ADDENDUM NO. 2

BELLE ISLE STATE PARK
NEW STORAGE BUILDING
11 PLEASURE DRIVE
DETROIT, MICHIGAN

FILE NO: 751/19193.SMD
WTA Project No. 2019131
DATE: November 3, 2026

1 A6.21 ROOF PLAN
NORTH
SCALE: 1/4" = 1'-0"

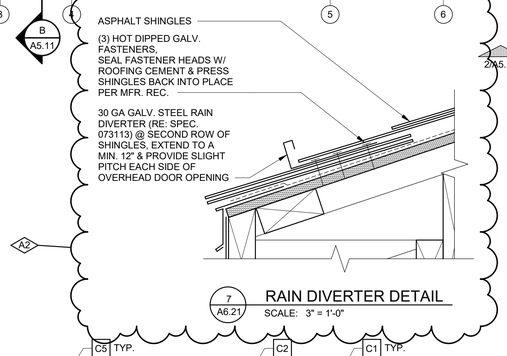
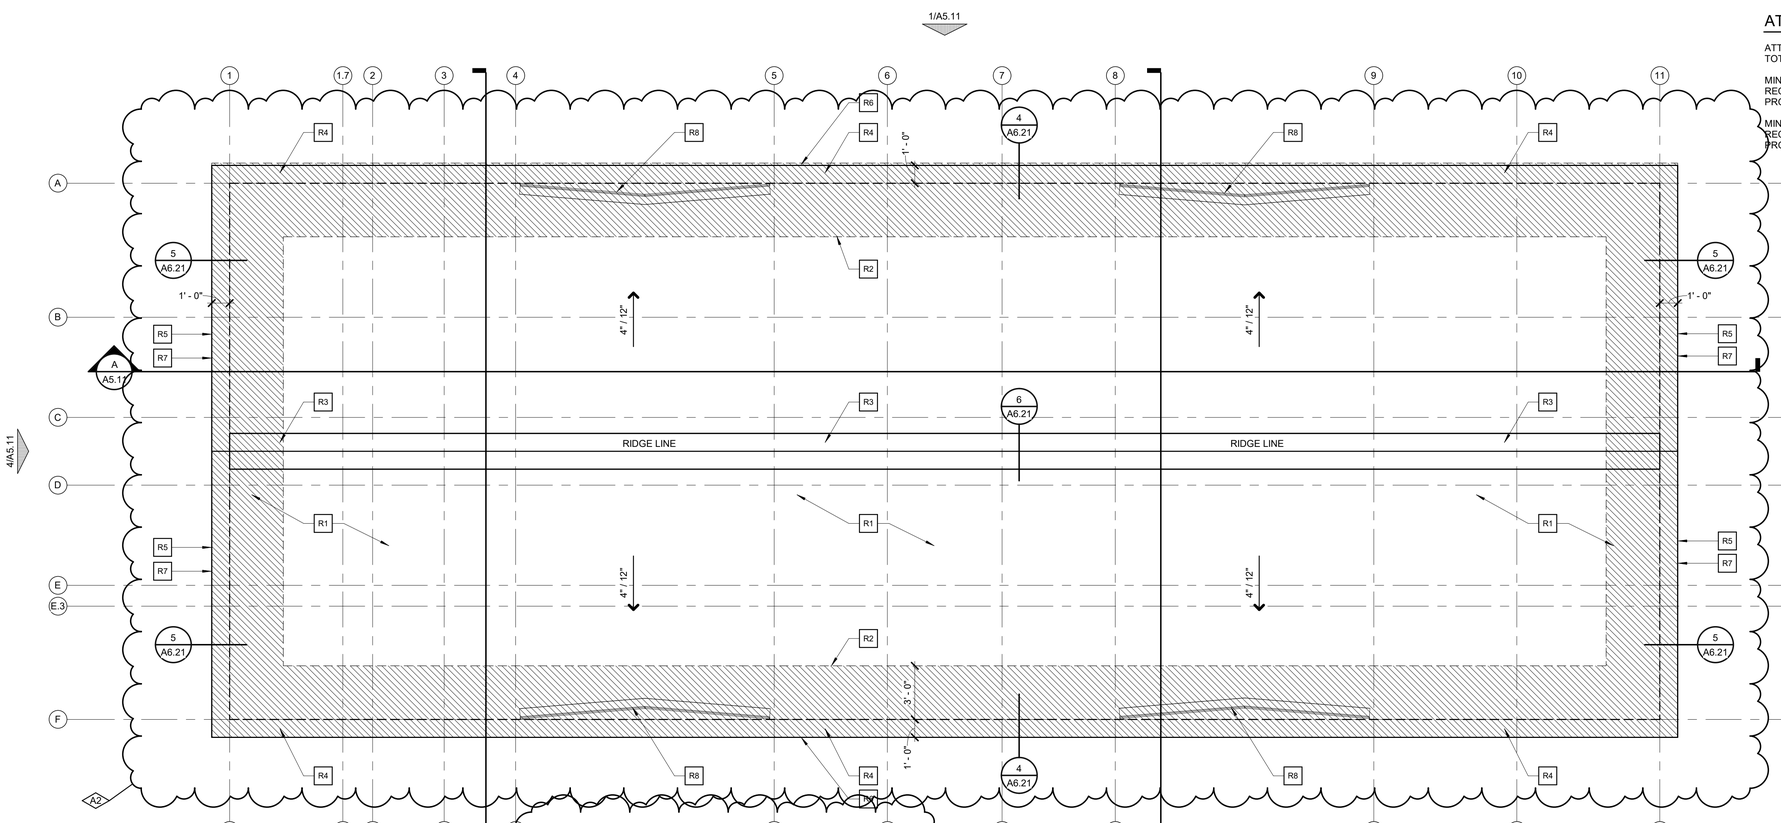
Item A6: Refer to Sheet A6.21 (Attached)
- A. Added rain diverter detail 7/A6.21.
- B. Revised roof plan for ice and water shield locations.
- C. Revised notes on details 4/A6.21, 5/A6.21, 6/A6.21, 7A6.21,

58. Ice and water shield extent: Specification 073113, 3.2.B requires self-adhered underlayment at eaves, rakes and ridges (36 in. each side of the ridge). The hatch on the A6.21 roof plan shows eaves only. Please confirm the required locations.

59. Fascia, rake trim and soffit: The A6.21 roof plan keynotes R4 and R7 show pre-finished aluminum fascia/rake trim and vented aluminum soffit. Section 074213.13 includes fasciae, rakes and soffits in the metal wall panel system, formed from the panel material. Please confirm which section and material govern.

RESPONSE:
Refer to Addendum 2.

RESPONSE:
Specification shall govern.

7 A6.21 RAIN DIVERTER DETAIL
SCALE: 3" = 1'-0"

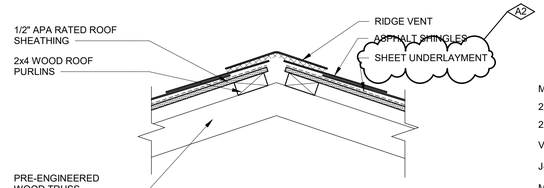
61. Rain guard diverters (A6.21 keynote R8; A5.11 keynote 31): No specification section or detail is provided. Please give the product, material and length required.

RESPONSE:
See Addendum 2.
